PROJECT:	LCE-APP-10
PART NUMBER:	80000116
ASSEMBLY NAME:	Zoom SDK Application Kit
SCHEMATICS:	ECR

LOGIC		411 WASHINGTON AVE. N MINNEAPOLIS, MN 55401	
		PRODUCT DEVELOPMENT		PHONE: (612) 672-9495 FAX: (612) 672-9489	
Title Zoom SDK Application Board					
Size C	Number 80000116	Rev G01			
Design Create Date = Monday, July 01, 2002		Project LCE-APP-10	Sheet 1 Of 12

02 - EXPANSION BUS

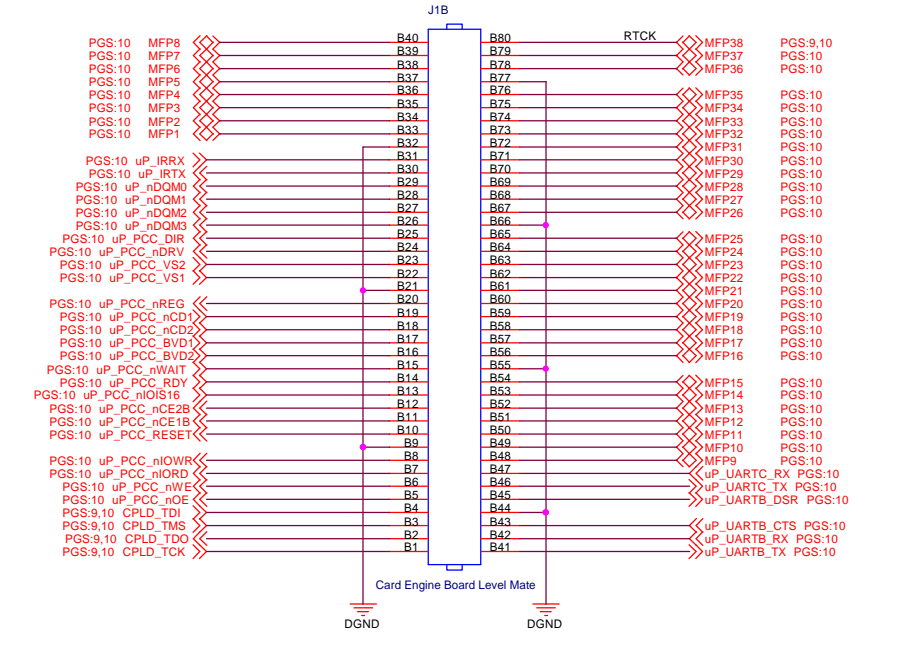
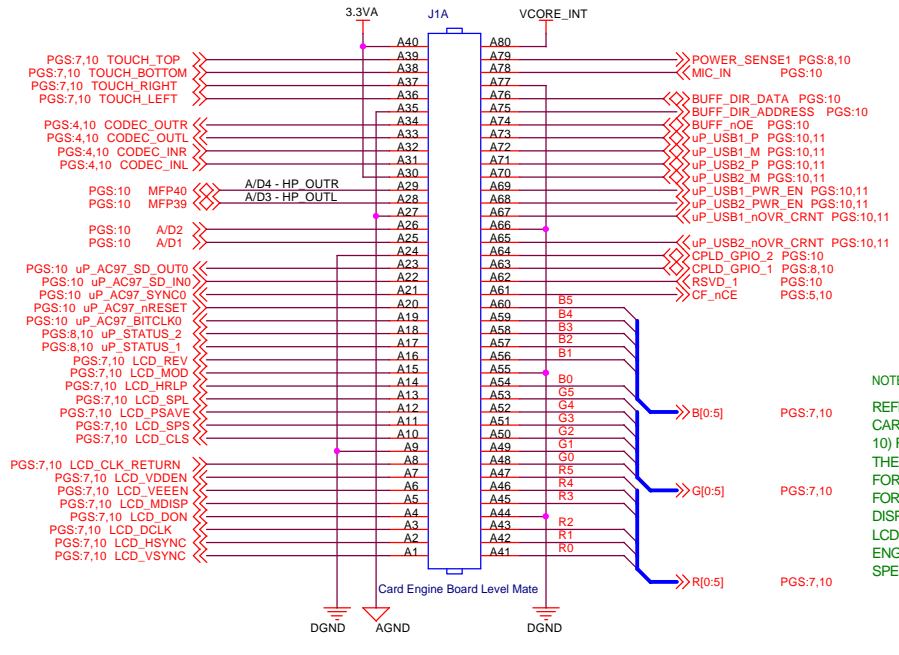
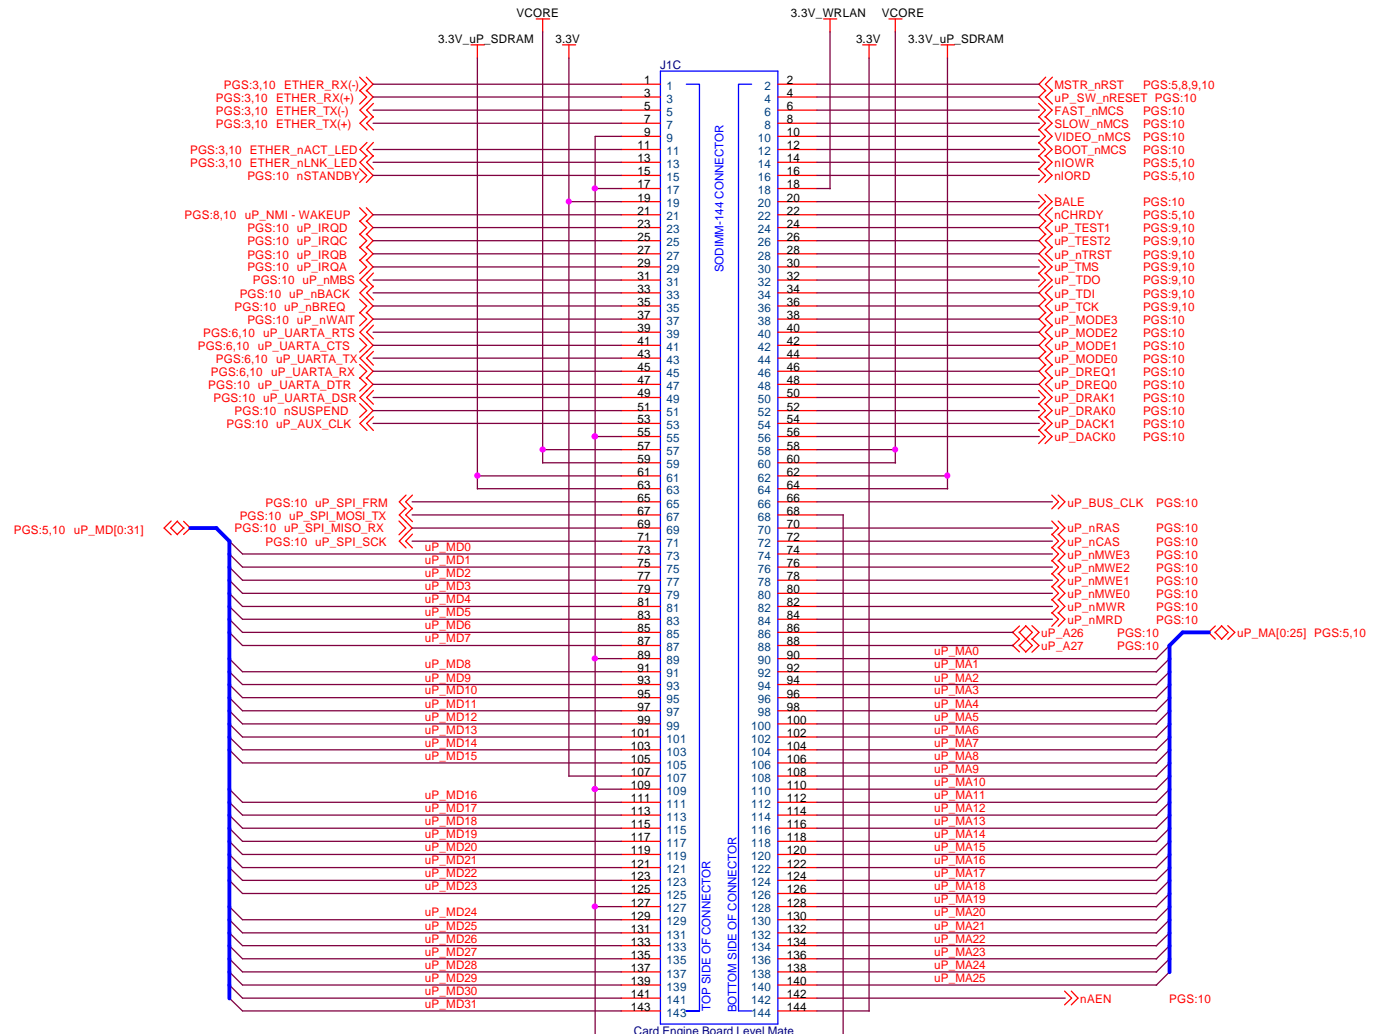
1. CHANGED NETS
A39 - TOUCH_TOP (was TOUCHX2)
A38 - TOUCH_BOTTOM (was TOUCHX)
A37 - TOUCH_RIGHT (was TOUCHY2)
A36 - TOUCH_LEFT (was TOUCHY)
2. REMOVED THE NET CF_RDYnBSY AND RENAMED THE NET RSV_D_1

1. CHANGED NET NAME OF uP_NMI (J1C.21) TO uP_NMI - WAKEUP TO ACCOMMODATE THE a400 AND A404.

1. SEPARATED THE 3.3V AND 3.3V_uP_SDRAM ON PINS 61-64 OF THE SODIMM CON
2. ADDED 3.3V_WRLAN TO THE DIMM CONNECTOR J1C.19
3. CHANGED NET NAMES TO FOLLOW NEW NAMING CONVENTION SHOWING ACTIVE LEVEL IE. MSTR_RST -> MSTR_nRST.
4. ADDED SIGNAL uP_RTCK TO MFG38 FROM THE 20PIN JTAG HEADER
5. SWITCHED THE PINS ON J1A THAT NETS LCD_PSAVE AND LCE_REV GO TO
6. RENAMED NET LCD_CLKIN -> LCD_CLK_RETURN AND NET LCD_CLKOUT -> LCD_DCLK
7. REMOVED R22

1. CHANGED DIRECTION OF NETS LCD_CLKIN AND LCD_CLKOUT
2. CHANGED THE NAMES OF THE LCD DATA LINES
3. CHANGED THE NET NAMES OF EVB1 AND EVB2 TO CF_nCE AND CF_BSYnRDY RESPECTIVELY

03 - ENGINE ETHERNET

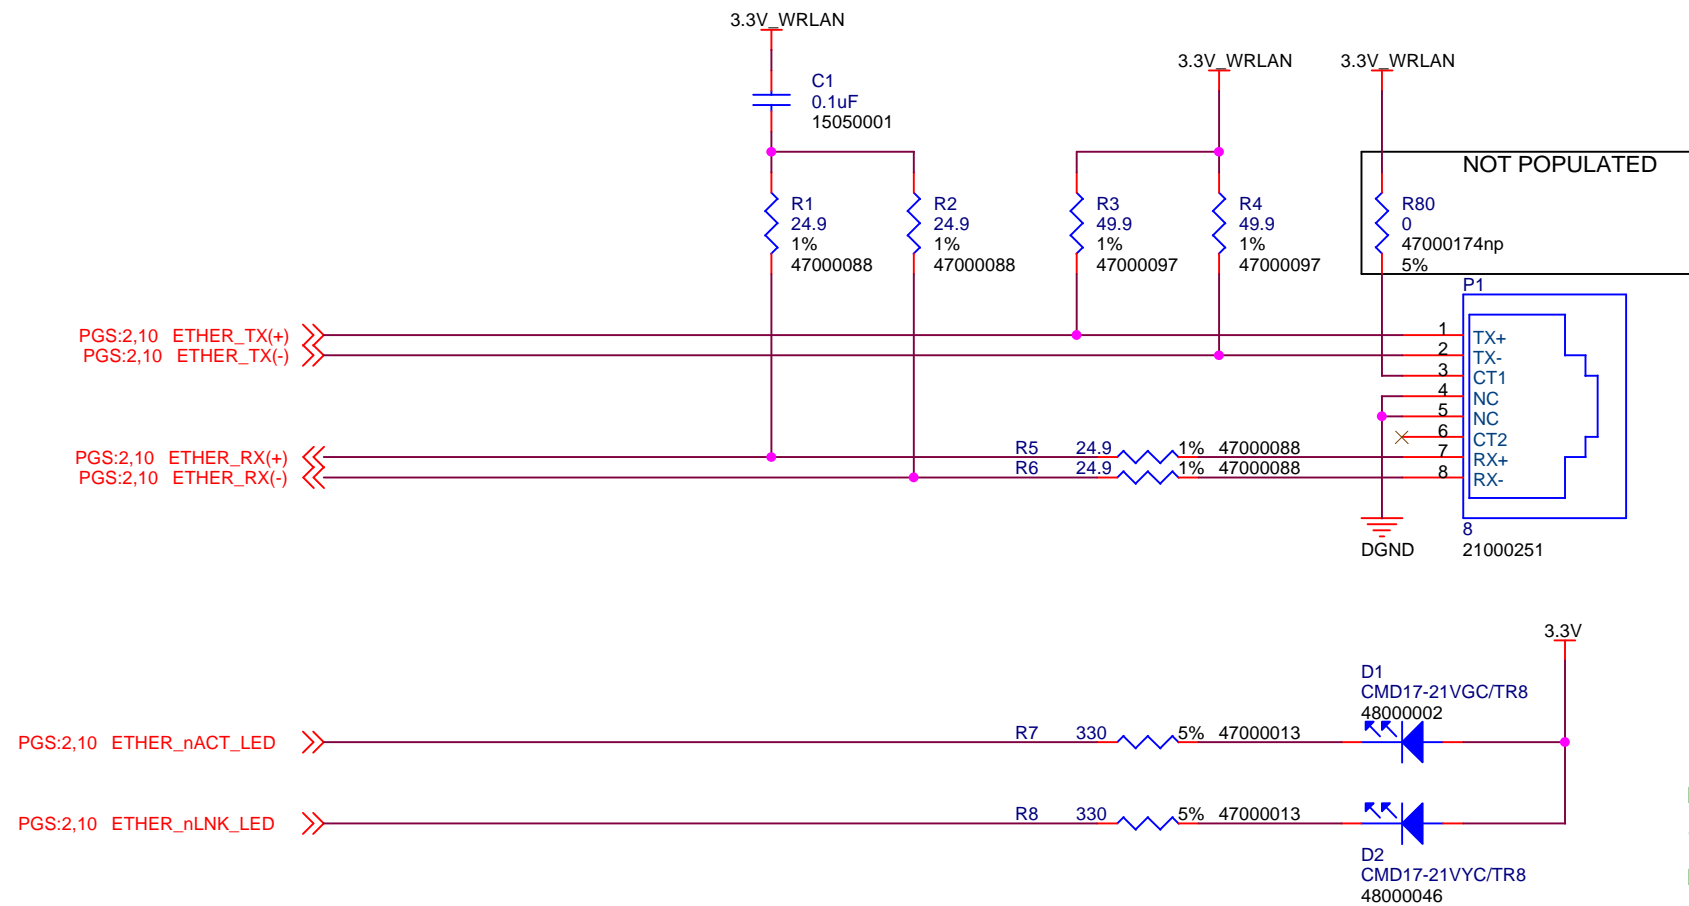
1. ADDED BOX AROUND THE NO POP RESISTOR ON ENET CONNECTOR

1. CONNECTED CT1 TO 3.3V_WRLAN PER 91C111 SCHEMATIC CHECKLIST PROVIDED BY SMSC
2. CHANGED THE CONNECTION OF CT1 TO 3.3V_WRLAN DIRECTLY TO ONE THAT USES A 0OHM (R80) UNTIL QA HAS BEEN COMPLETED.

1. CHANGED THE IMPEDENCE MATCHING VOLTAGE ON THE ENET TX AND RX LINES TO 3.3V_WRLAN
2. CHANGED THE NET NAMES OF THE LNK AND ACT LED NETS TO ETHER_nACT_LED AND ETHER_nLNK_LED
3. CHANGED THE NET NAMES OF THE LNK AND ACT LED NETS TO ETHER_nACT_LED AND ETHER_nLNK_LED
4. CHANGED R3 AND R4 FROM 47 OHM 5%S TO 49.9 OHM 1%S
5. GROUNDED PINS 4 AND 5 OF P1, PER PULSE CONNECTOR SPEC
6. CHANGED R1,R2,R5,R6 FROM 24 OHM 5%S TO 24.9 OHM 1%S

COMPACT FLASH
SOCKET MEMORY
MODE ONLY

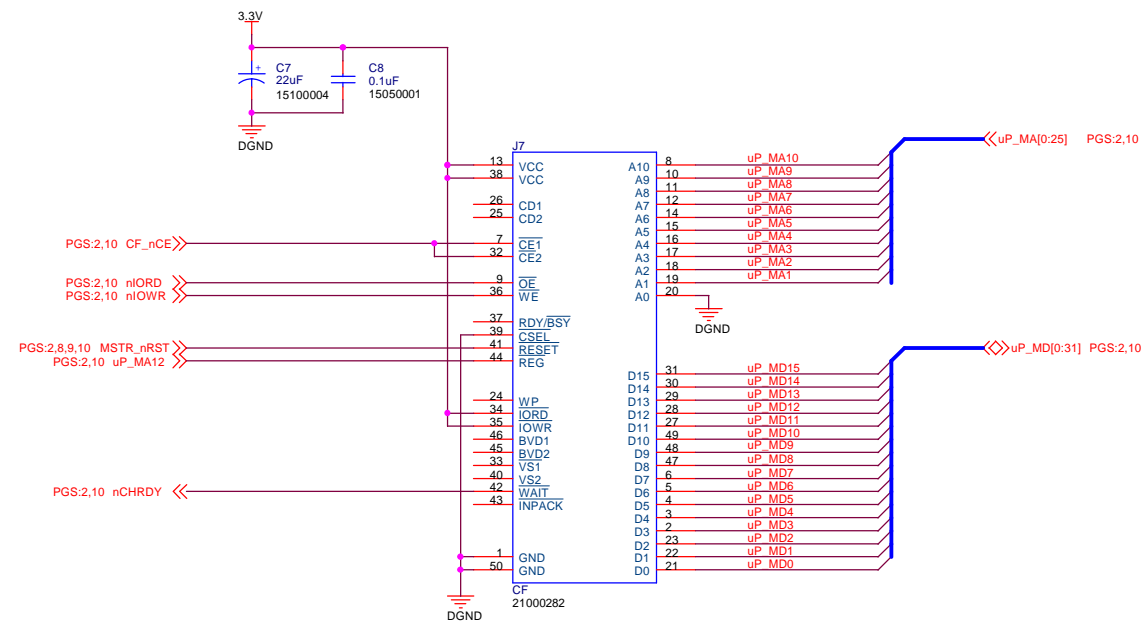
1. REMOVED A0 FROM CF CONNECTOR FOR COMPATABILITY WITH A400 BSC IN A 16BIT AREA

1. CHANGED NET THAT CONNECTS TO REG ON J7.44 FROM uP_MA13 TO uP_MA12
2. REMOVED THE NET CF_RDYnBSY

1. CHANGED NET THAT CONNECTS TO REG ON J7.44 FROM uP_MA11 TO uP_MA13
2. REMOVED PULLUP ON CF_RDYnBSY

1. ADDED NET uP_MA3 TO J7.17 FOR 16BIT ADDRESSABILITY
2. CHANGED NETS MFP3 AND MFP6 TO EVB1 AND EVB2
3. REMOVED NET uP_MA0 AND TIED THAT PIN ON J7 TO GND
4. REMOVED HOT SWAPPABILITY, DELETED NETS uP_PCCDRV AND CF_3.3V, AND COMPONENTS Q1, C10
5. ADDED ADDRESS LINES uP_MA0,4-9 AND uP_MA11 FOR GREATER FUNCTIONALITY AND USABILITY OF MORE CF CARDS
6. CHANGED THE NET NAMES OF EVB1 AND EVB2 TO CF_nCE AND CF_BSYnRDY RESPECTIVELY

07 - VIDEO

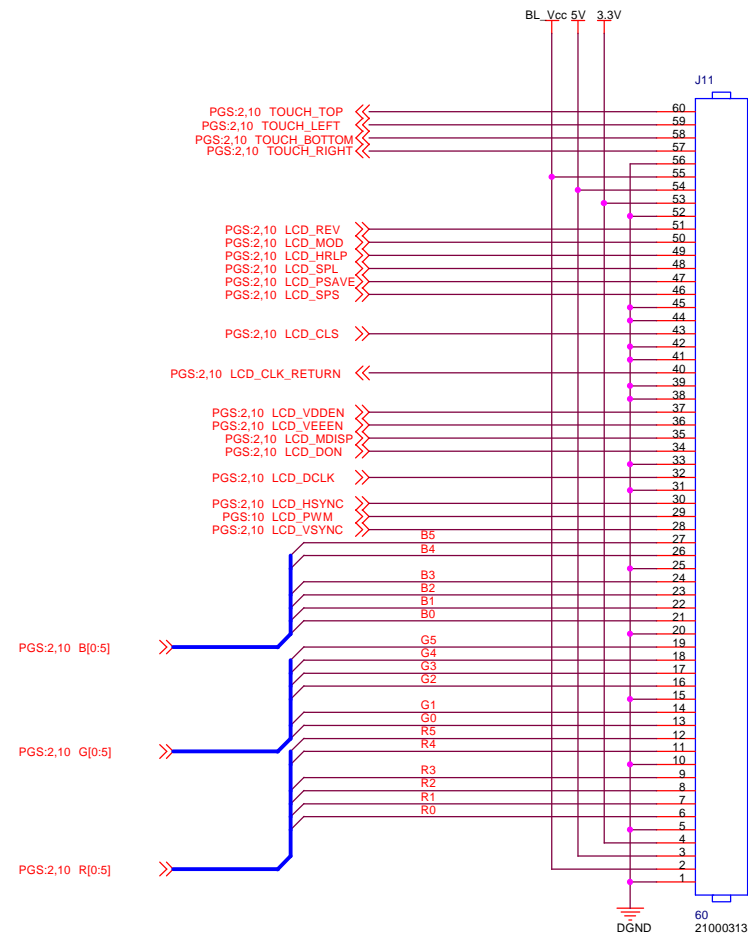
1. CHANGED NETS
A39 - TOUCH_TOP (was TOUCHX2)
A38 - TOUCH_BOTTOM (was TOUCHX)
A37 - TOUCH_RIGHT (was TOUCHY2)
A36 - TOUCH_LEFT (was TOUCHY)

1. CHANGED THE 60PIN LCD CONNECTOR J11 TO A SHROUDED/KEYEDW
EJECTOR TABS TYPE
2. SWITCHED THE PINS ON J11 THAT NETS LCD_PSAVE
AND LCE_REV GO TO
3. RENAMED NET LCD_CLKIN -> LCD_CLK_RETURN
AND NET LCD_CLKOUT -> LCD_DCLK

1. CHANGED DIRECTION OF NETS LCD_CLKIN AND
LCD_CLKOUT
2. CHANGED THE NAMES OF THE LCD DATA LINES

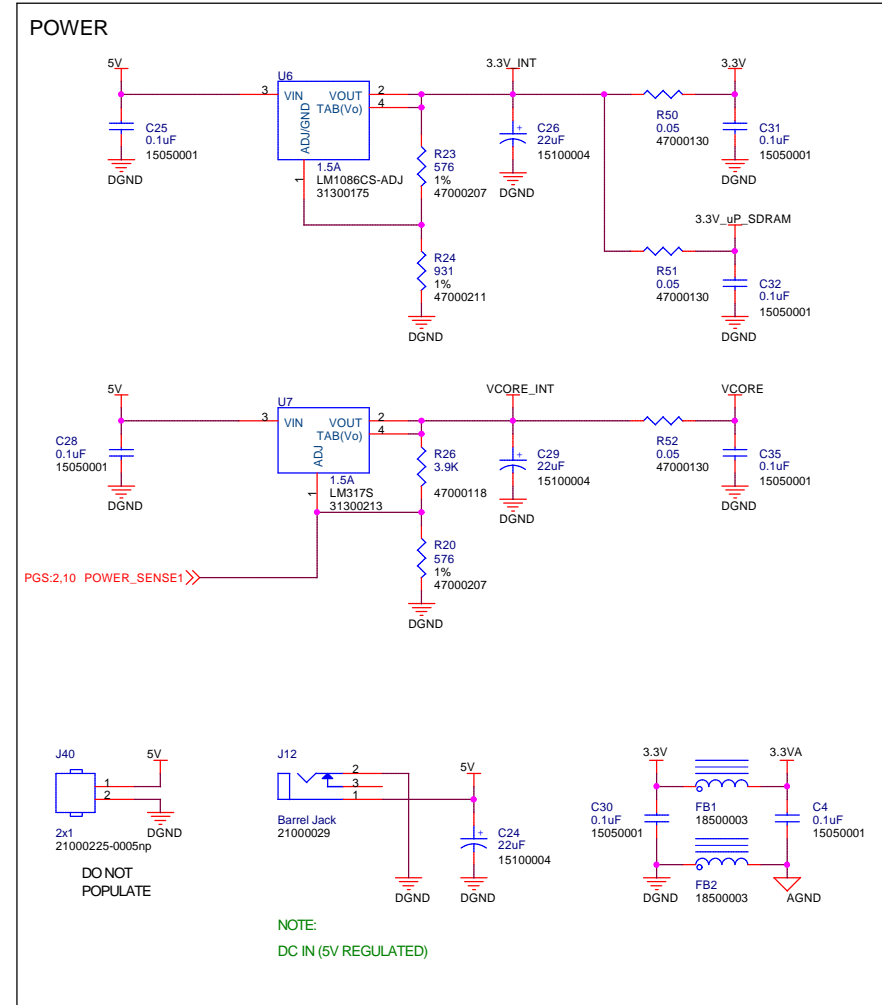
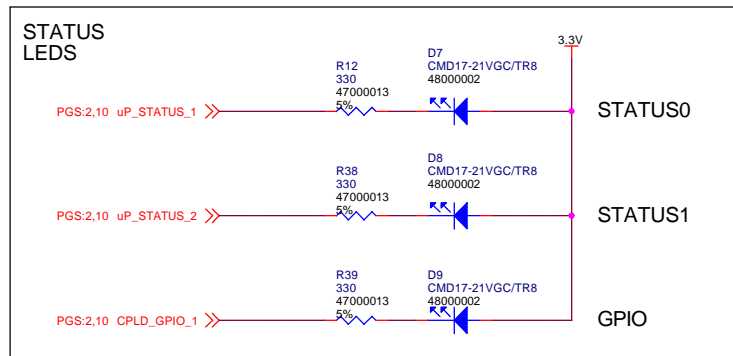
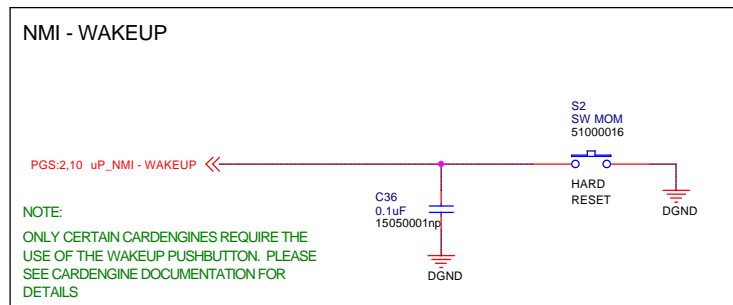
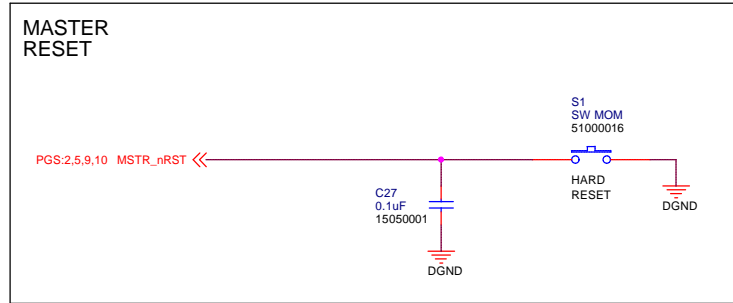
1. CHANGED J40 FROM BL_VCC TO 5V AND GND
2. MADE C36 A NO POP

1. ADDED THE CIRCUIT NMI - WAKEUP AND CHANGED NET uP_NMI TO uP_NMI - WAKEUP

1. CHANGED J40 FROM POPULATE TO DO NOT POPULATE
2. SEPARATED THE 3.3V AND 3.3V_uP_SDRAM
3. ADD SENSE RESISTORS AND .1uF CAPS TO THE 3 PLANES VCORE, 3.3V, AND 3.3V_uP_SDRAM
4. CHANGED NET NAMES TO FOLLOW NEW NAMING CONVENTION SHOWING ACTIVE LEVEL IE. MSTR_RST -> MSTR_nRST.
5. CHANGED REF DES J40np TO J40

1. CHANGED THE NETS THAT CONTROL THE LEDES FROM MFP11, MFP12, MFP4 TO uP_STATUS1, uP_STATUS2, CPLD_GPIO1
2. CHANGED U6 TO AN LDO REGULATOR
